# PENRITH CITY COUNCIL

## MAJOR ASSESSMENT REPORT

Application number:	DA18/0240
Proposed development:	Demolition of Existing Structures, Construction of a Six (6) Storey Residential Flat Building containing 45 Apartments and Two (2) Levels of Basement Car Parking
Property address:	43 Barber Avenue, PENRITH NSW 2750 41 Barber Avenue, PENRITH NSW 2750
Property description:	Lot 31 DP 2296 Lot 30 DP 2296
Date received:	12 March 2018
Assessing officer	Kathryn Saunders
Zoning:	Zone R4 High Density Residential - LEP 2010
Class of building:	Class 2, Class 7a
Recommendations:	Refuse

ELEVATIONS	
PRELIMINARY NOT FOR CONSTRUCTION

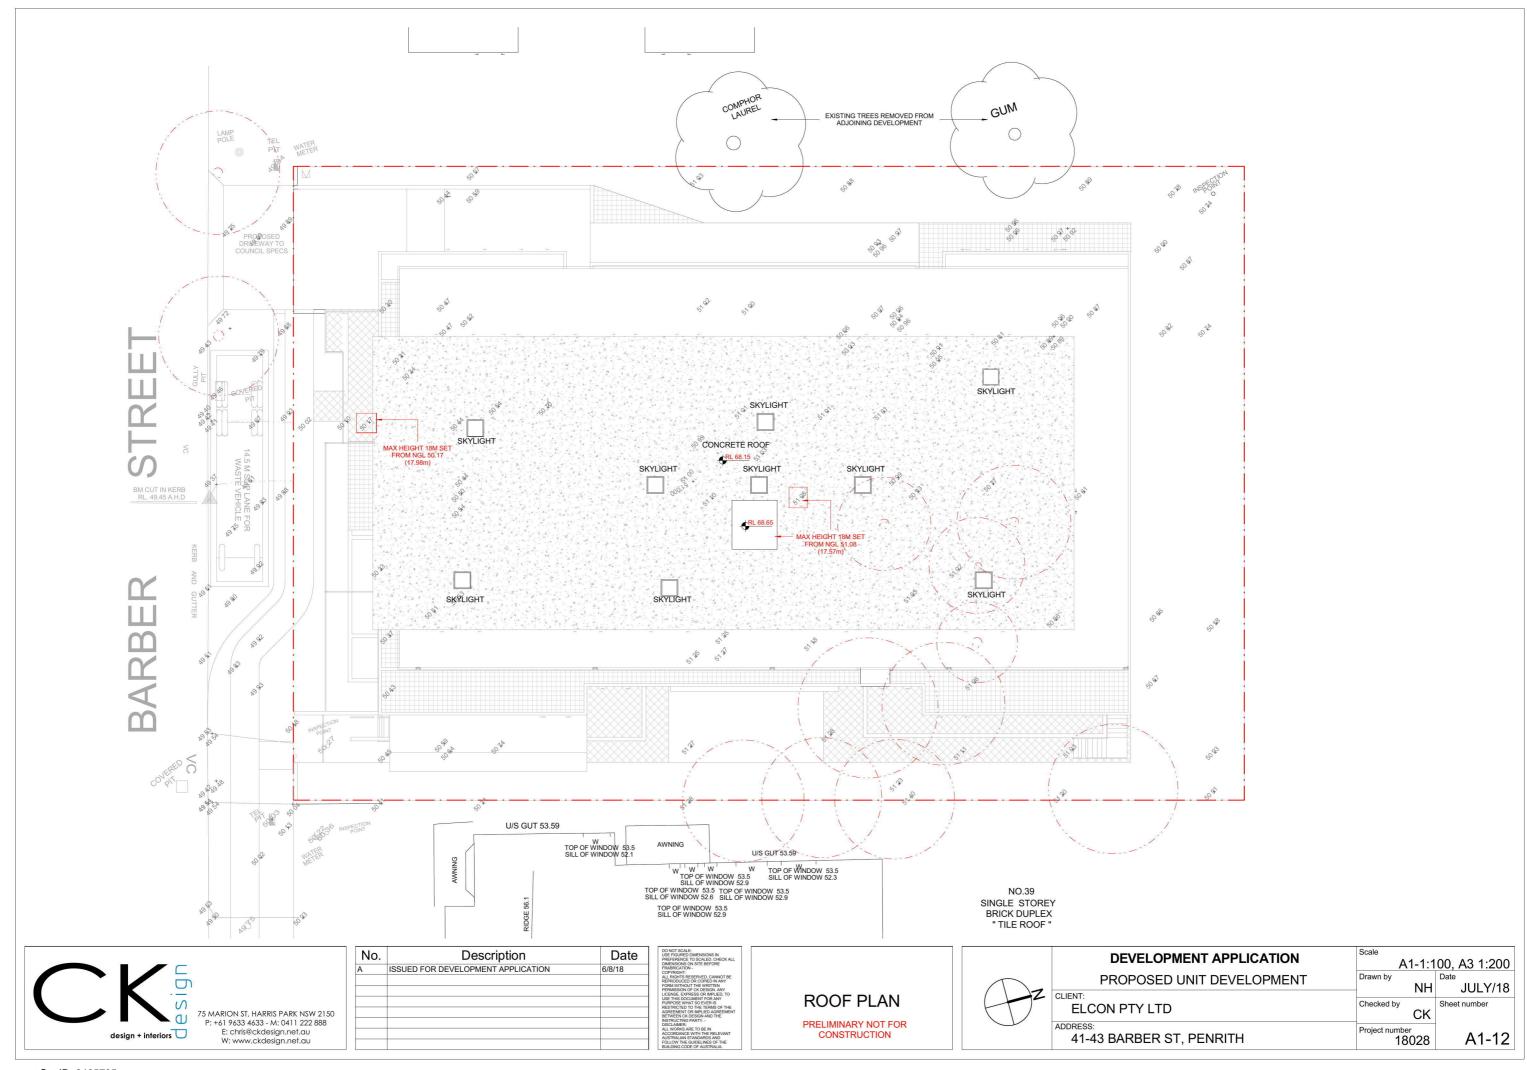
and 6.  It is unclear how the reduced separation distances impact the balconies and windows of the apartment building to the west as plans do not include sufficient detail.  In this respect, the reduced separation distances are not supported.

- The streetscape elevation plan does not show sufficient detail to understand the environmental impacts of reduced building separation distances.
- The landscape plan does not correlate with the architectural plans or the concept stormwater/hydraulic
  plans. In particular, the area nominated as 'deep soil' on the architectural plans is also the area
  nominated for an On Site Detention Tank with a concrete lid at RL 50.20m AHD which is 20mm higher
  than the finished floor area of the ground floor lobby.

BUILDING HEIGHT
PLANE
PRELIMINARY NOT FOR
CONSTRUCTION

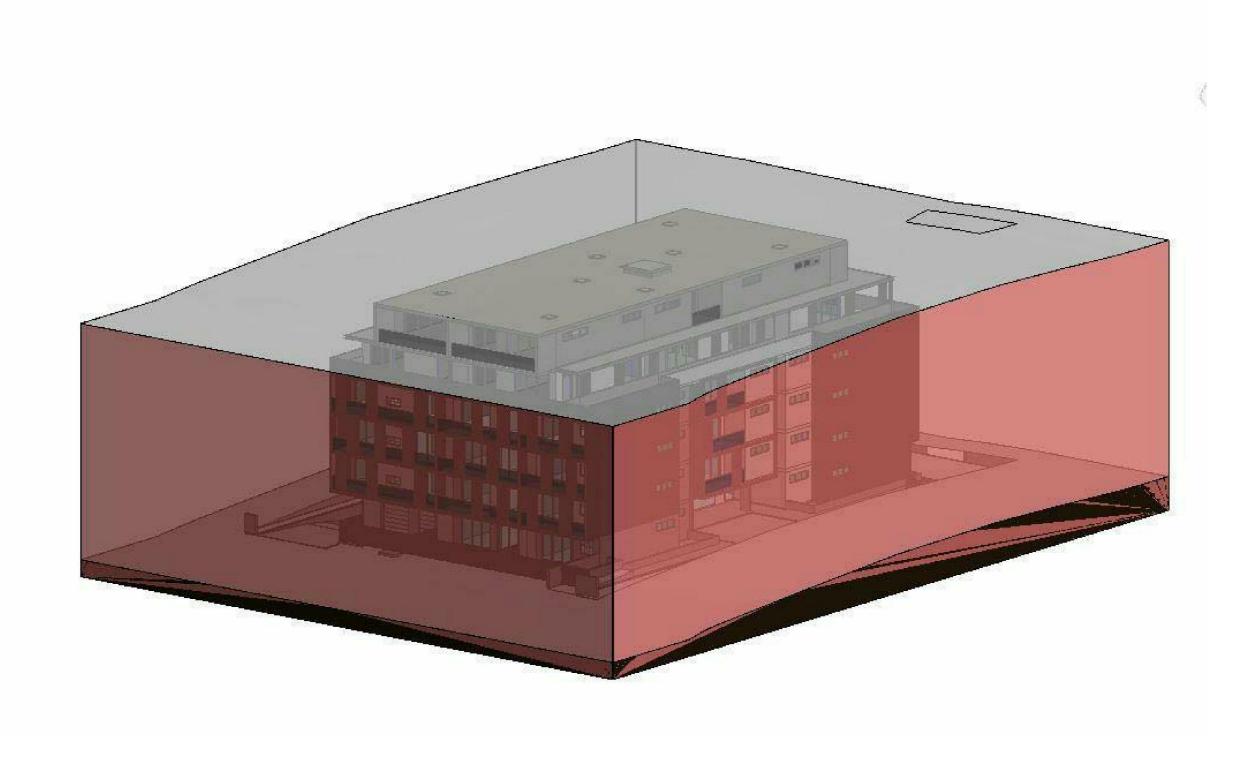
The proposal complies with the maximum permissible height of 18m under PLEP 2010. No floor space ratio applies to the site.

Built Form and Scale - Height is non-compliant and insufficient planning grounds provided to justify [note: The proposed height has been amended and is now proposed to be compliant], fifth and sixth storeys should incorporate pronounced setbacks from levels below: these levels in the current street elevation have additional setback of 0.5m which is not sufficient, side elevations display excessive bulk due to the extent of planar

SITE ISOLATION
PLAN
PRELIMINARY NOT FOR
CONSTRUCTION

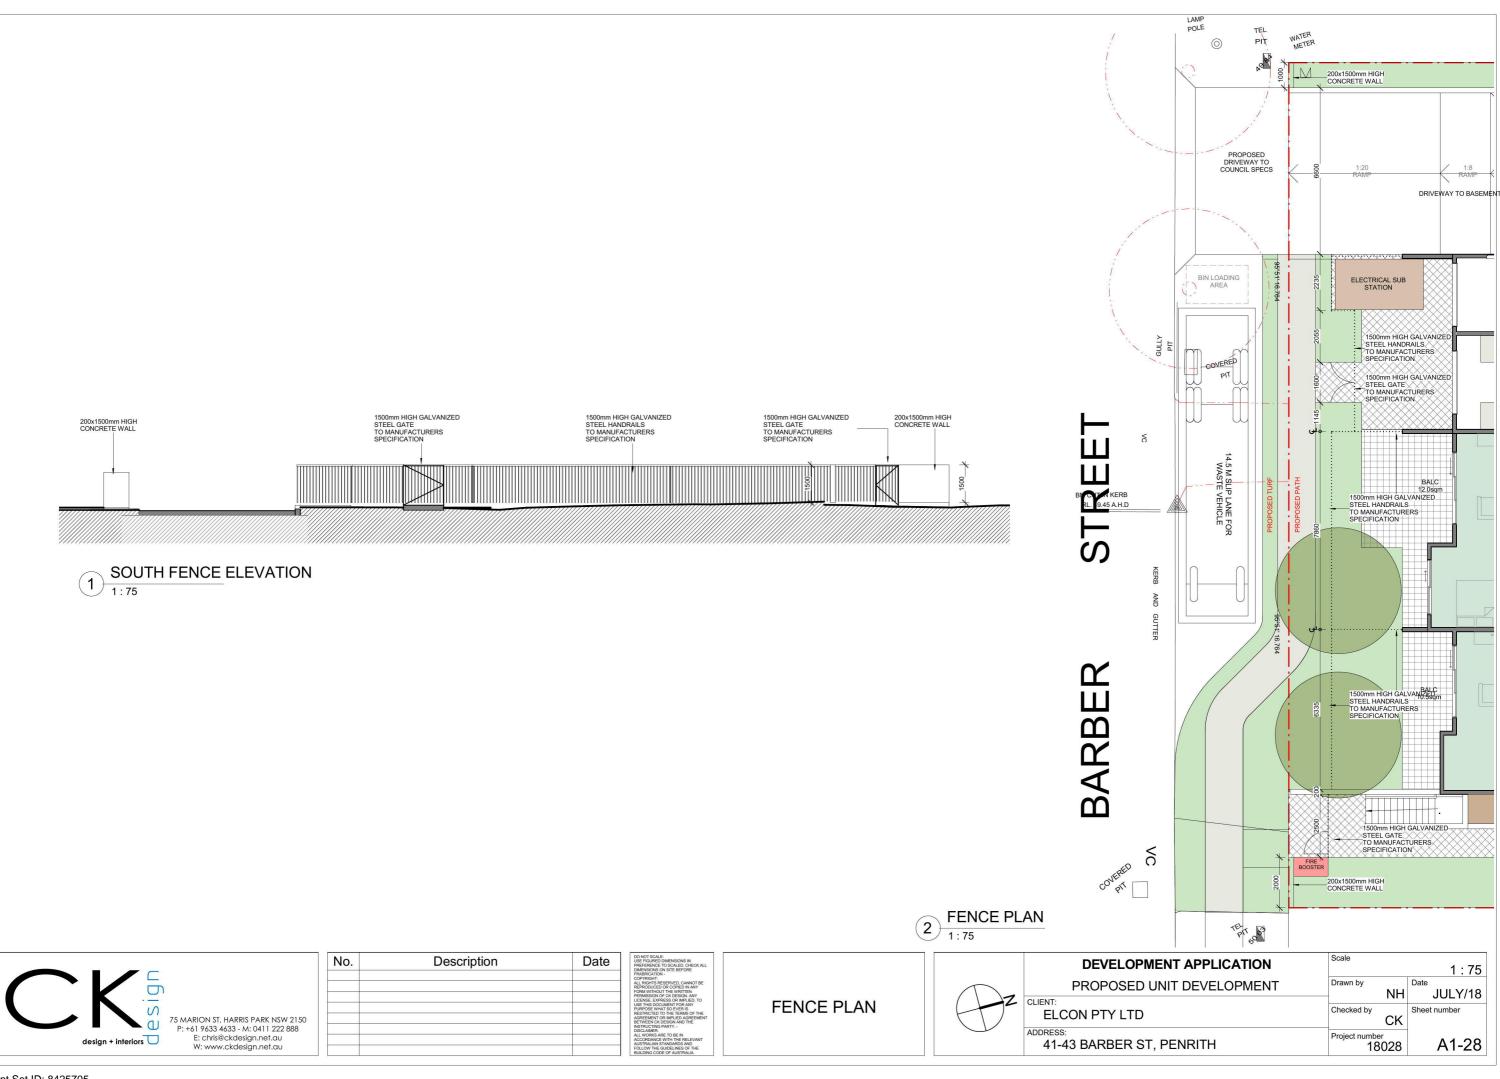
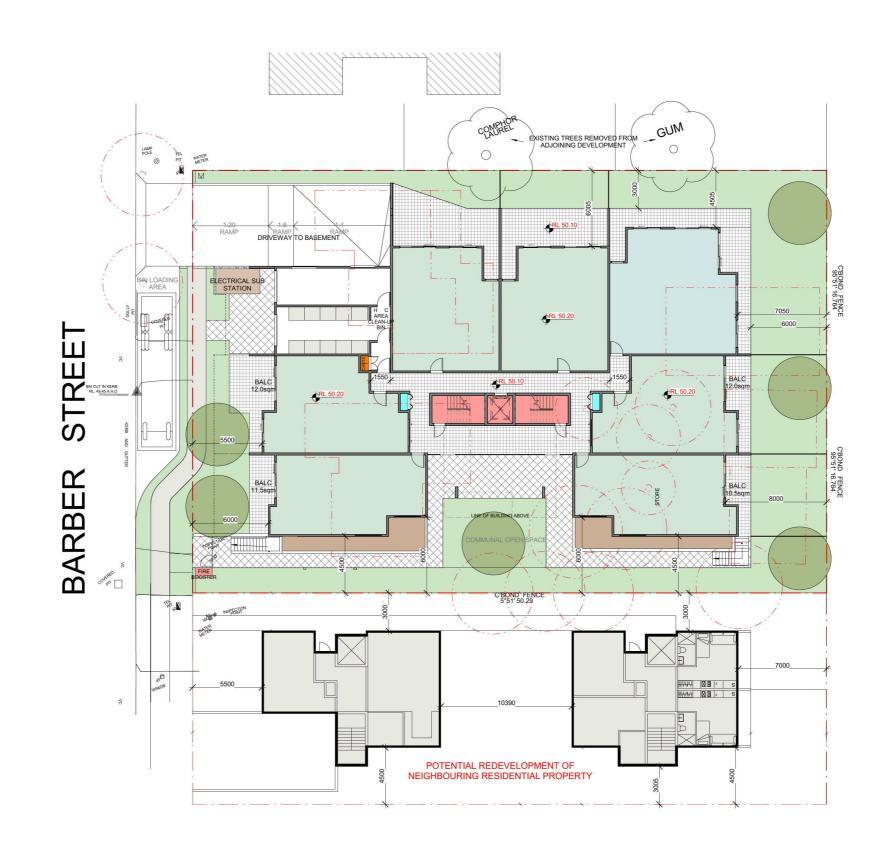
The single storey dual occupancy development at 39 and 39a Barber Avenue, which shares its western boundary with the subject site, will be isolated by the proposed development. The Land and Environment Court of NSW has established Planning Principles with regard to redevelopment.

It is not agreed that the site is not isolated by the proposed development as the site is not of a sufficient area or proportion to allow development for the purposes of a residential flat building. The submitted boarding house plans have been reviewed and it is not demonstrated that a proposal for a 6 storey boarding house could be supported given the constraints of the site.

The limited side setbacks and landscaping proposed as part of the development application will result in impacts of overbearing and privacy which will be detrimental to the occupants of the adjoining site and the design response does not take into consideration these impacts on the isolated property.
